APPEAL SUMMARY

Appeal ID: 21921	Project Address: 1316 NE Broadway
Hearing Date: 9/25/19	Appellant Name: Brett Schulz
Case No.: B-014	Appellant Phone: 503-222-9099
Appeal Type: Building	Plans Examiner/Inspector: Preliminary
Project Type: commercial	Stories: 3 Occupancy: S, B, R-3 Construction Type: V-B
Building/Business Name:	Fire Sprinklers: Yes - Basement
Appeal Involves: Alteration of an existing structure, occ Change from S to R3	LUR or Permit Application No.:
Plan Submitted Option: pdf [File 1] [File 2]	Proposed use: Office and residential

APPEAL INFORMATION SHEET

STAIR PLAN

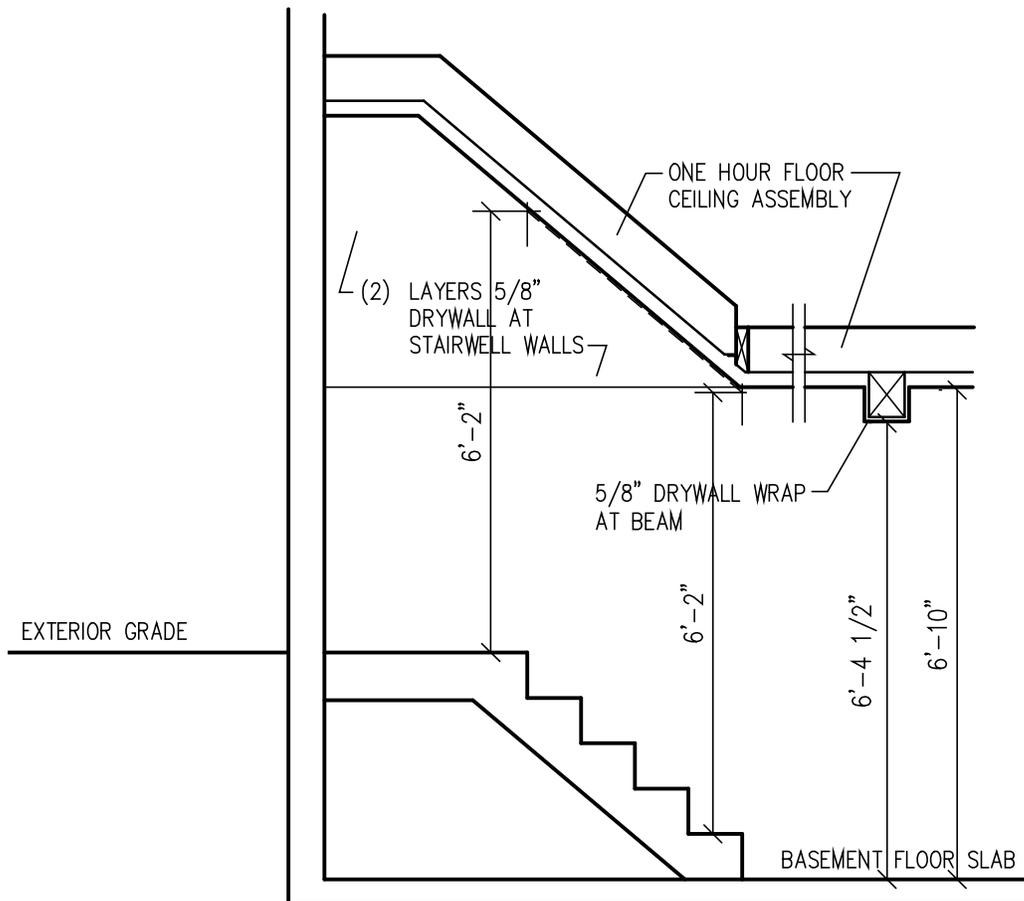
Proposed Design See attached Stair Plan. Appellant proposes that the requirements of Brochure #9 be applied here as the stairs are within a single dwelling unit. Brochure #9 allows landings of 30"x30". Proposed

design has a 36"x36" landing at the bottom of the 36" wide stairs and a 66" wide by 34" deep landing at the top, with an angled transition from the 34" deep portion to the wider portion.

Reason for alternative A larger top landing is not possible due to constraints of the existing stairwell opening. Because the top landing is wide and offset from the entry door, it provides more than equivalent landing area. The landing is larger than the 36"x36" area allowed for rebuilt stairs per Brochure #9 and therefore provides equivalent fire and life safety.

- 6. Reduction in minimum required headroom at existing stairs to 6' 2": Denied. Proposal does not provide equivalent Life Safety protection.**
- 7. Reduction in minimum required landing depth to 36 inches: Denied. Proposal does not provide equivalent Life Safety protection.**
